Prepared for
Art Gallery of New South Wales Trust

Date
6 November 2020

Section 4.55(2) Modification

Art Gallery of NSW Expansion - Sydney Modern Project

Figure 7. Landscape plan of the Entry Plaza, as approved under SSD 6471
Source: McGregor Coxall Landscape Architects

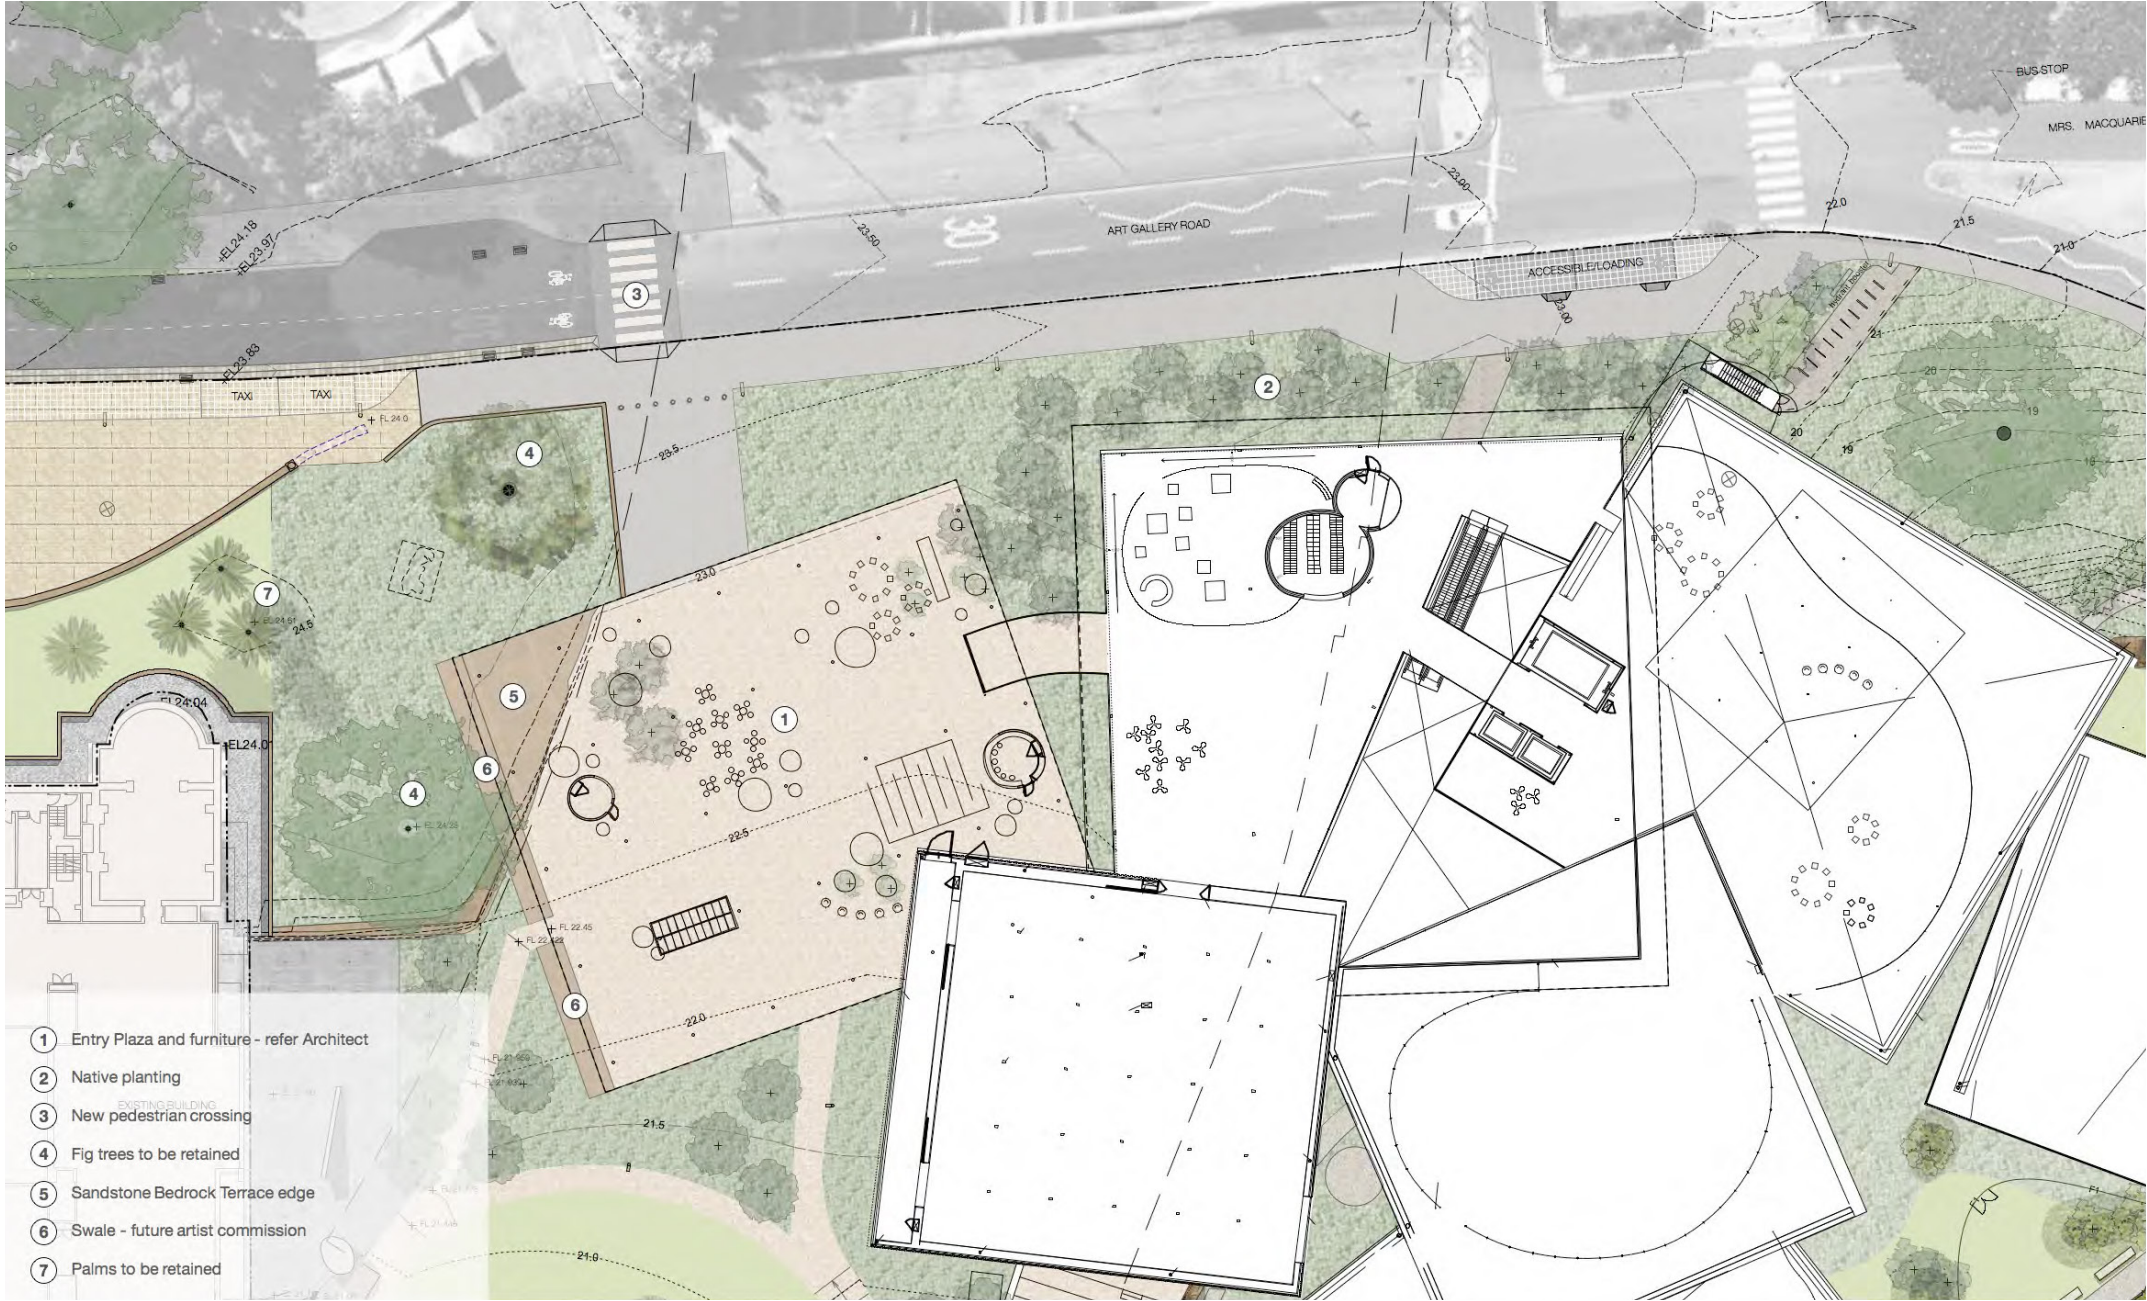
- New paving along Art Gallery Road
- New low bench / retaining wall along Art Gallery Road
- New paving at the entrance to the Entry Plaza to match the forecourt paving in front of the existing Gallery building
- Inclusion of a rain catcher and sandstone channel adjacent to the Entry Plaza to catch water during rain events from the glazed roof canopy of the Entry Plaza
- Tree and shrub planting under the Entry Plaza canopy to be provided in free-standing planters, rather than in-ground planting

“The Entry Plaza is complemented by a proposed new circular outdoor gathering space with views out to Sydney Harbour and Woolloomooloo Bay. The Entry Plaza and new gathering space are connected by a network of pedestrian pathways designed to create a garden experience highlighting native endemic plants.”

Figure 12. Proposed landscape plan of the Gathering Space and Crescent Hill under the Proposed Modification
Source: Gustafson Guthrie Nichol (GGN) Landscape Architects and McGregor Coxall Landscape Architects

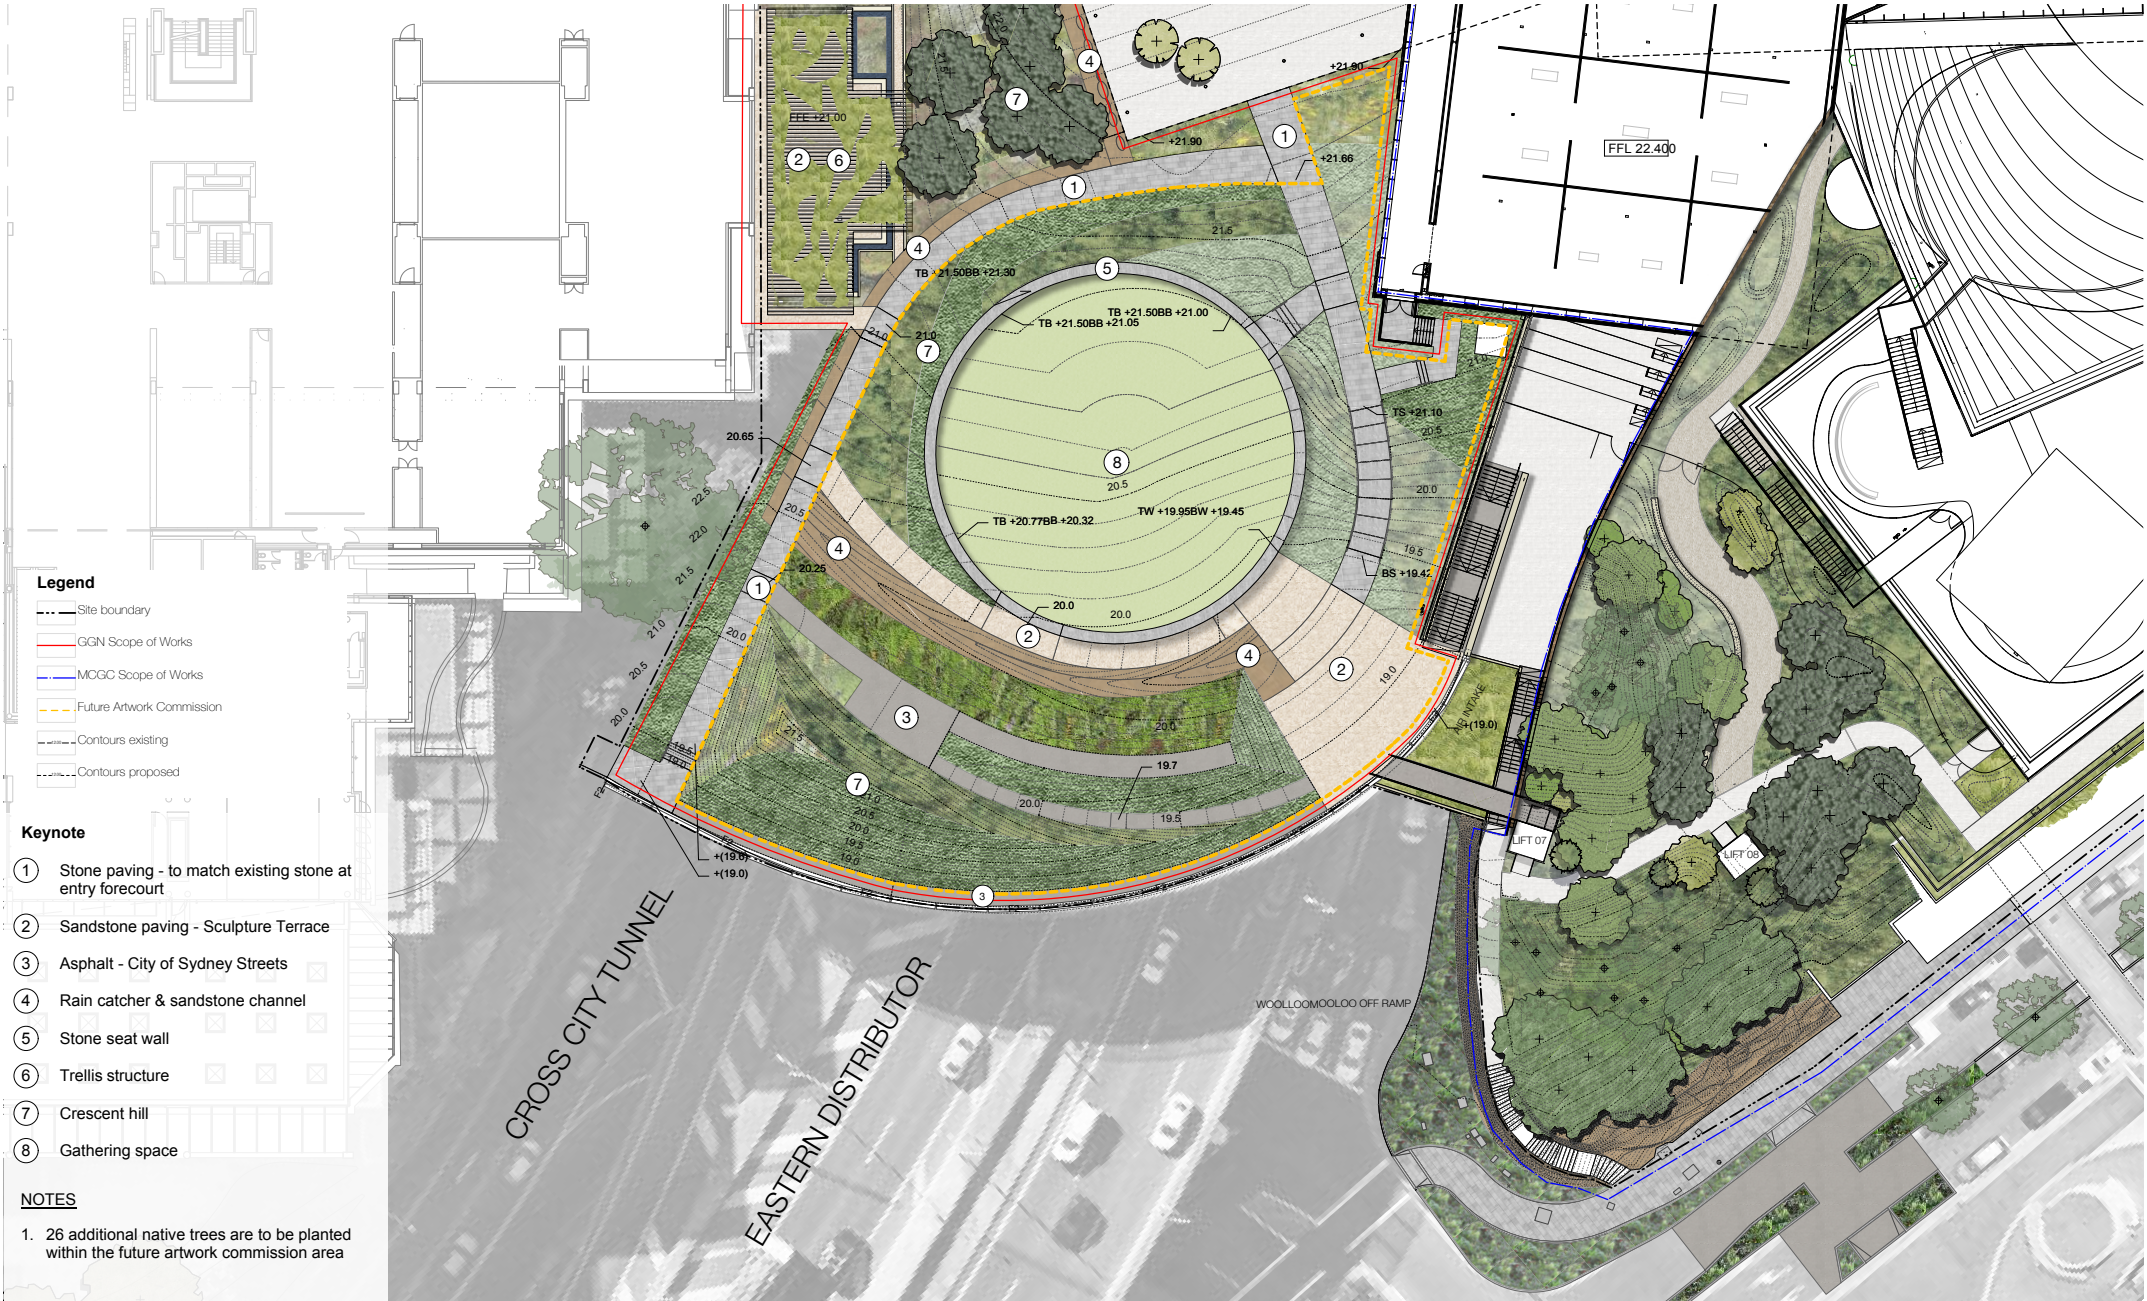
- New sandstone paving
- New asphalt footpath
- Inclusion of a sandstone channel connected to the Entry Plaza rain catcher
- New crescent-shaped earth berm ('Crescent Hill') adjacent to the edge of the land bridge, including new tree and shrub planting

- An artwork commission zone as the site for a future major art commission with provision for new tree planting
- Reinstatement of terrace, new trellis structure and water feature adjacent to the existing Gallery building in place of the area formerly known as the 'Northern Sculpture Court'. The area will be associated with the existing Gallery building and will have controlled access via the art garden. Access will predominantly be via existing doors within the northern façade of the existing Gallery building. The area will include new planting.

“Paralleling the pathways is a sandstone channel that starts along the southern edge of the Entry Plaza. This channel is intended to catch rainwater from the glazed roof of the Entry Plaza and convey it to a receiving basin on the eastern end of the land bridge.”
